Flood & Water Management Act 2010

Pre-Application Advice on SuDS on new developments, with reference to The Sustainable Drainage Regulations 2018.

1. Overview	
SAB Reference	YM2024SAB226 - Maes Mona, Amlwch
Project / Site Name	Maes Mona, Amlwch
Description of proposed	Construction of 40 no. dwellings with associated access roads,
development	car parking and gardens across 2 phases.

Figure 1 – Phase 2 Below Ground Storage.

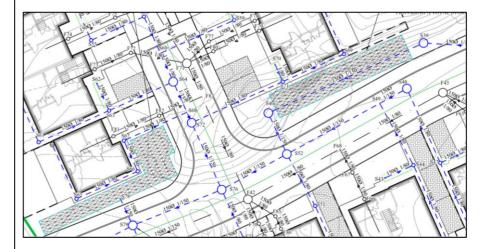
Attenuation storage for Phase 2 will be provided in the form of below ground geo-cellular storage and an offline detention basin. The applicant should clarify whether the below ground geo-cellular storage (shown in Figure 1) is located beneath public open space, or within private property

gardens. Shared attenuation storage features will not be acceptable beneath private property gardens.
